SUBJECT: **NEW VEHICLE DEMONSTRATION / DELIVERY HOLD**
Compliance Recall 22C22 - Supplement #4
Certain 2022 Model Year Bronco Sport and F-150 Vehicles
Front Park Lamp Flicker

REF: **NEW VEHICLE DEMONSTRATION / DELIVERY HOLD**
Compliance Recall 22C22 - Supplement #3
Dated: November 30, 2023

New! REASON FOR THIS SUPPLEMENT

FIGURE 1

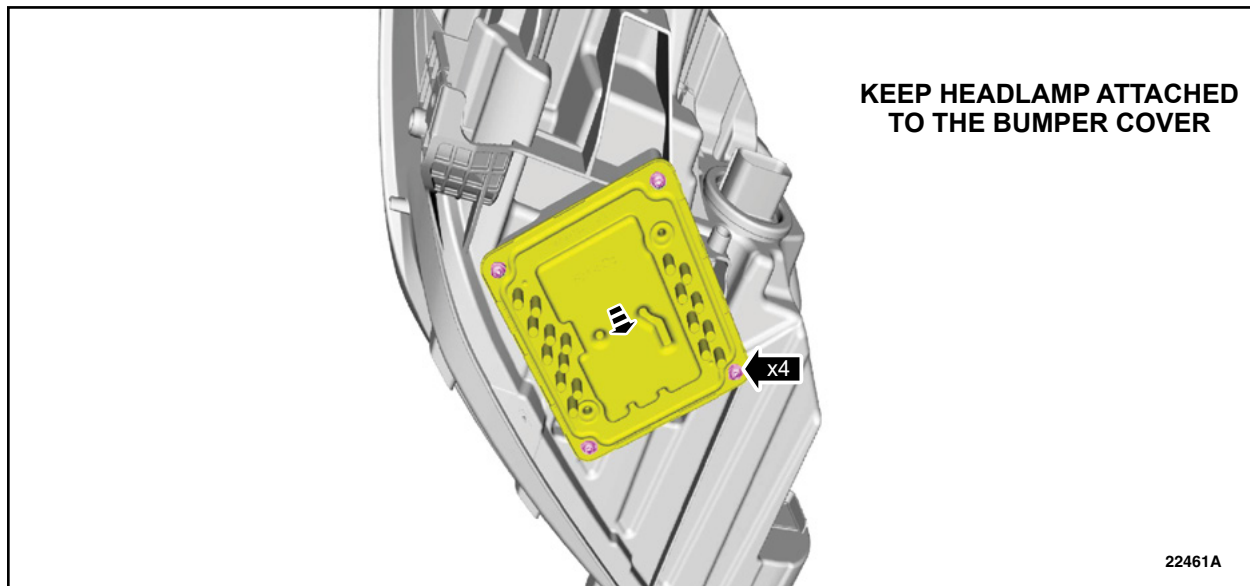
2. Remove the screws and release the Light Emitting Diode (LED) Control Module from the headlamp assemblies. See Figure 1.

FIGURE 2

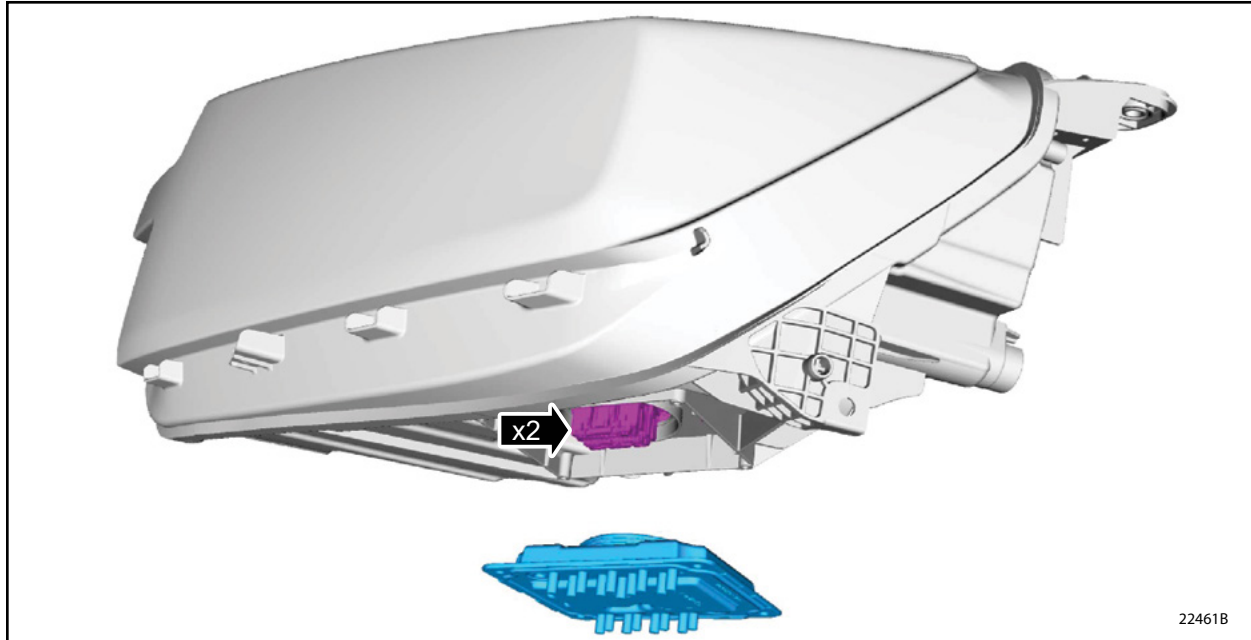
3. Disconnect the electrical connectors, and then remove and replace the LED control modules on both LH/RH sides. See Figure 2.

FIGURE 3

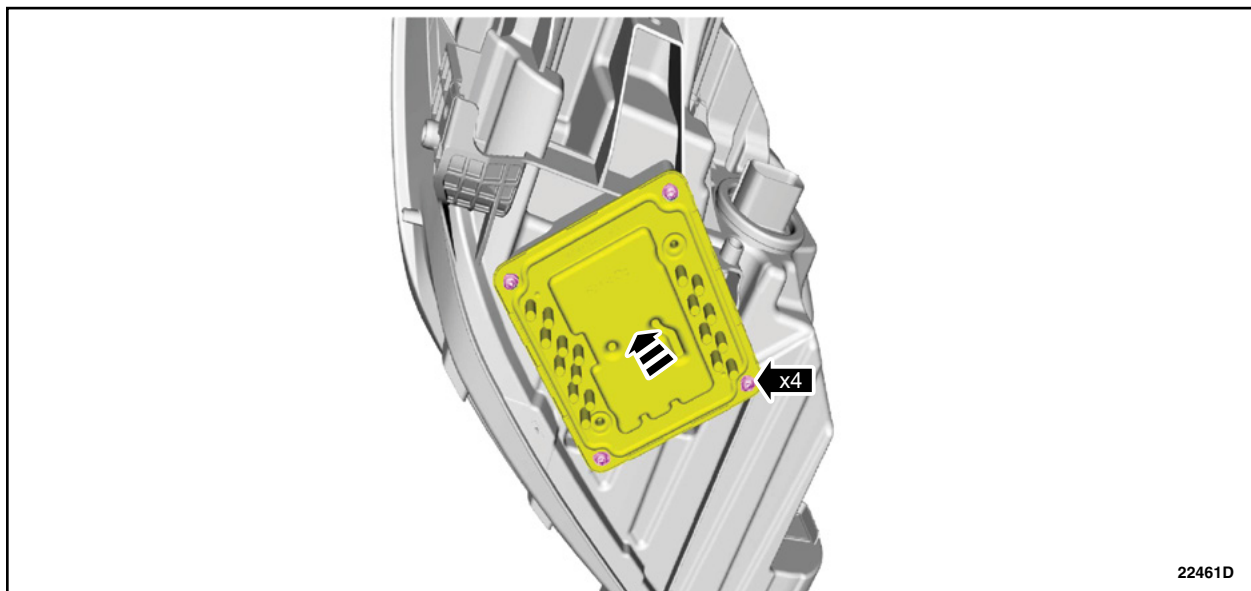
4. Position the *new* LED control module and install the screws. See Figure 3.
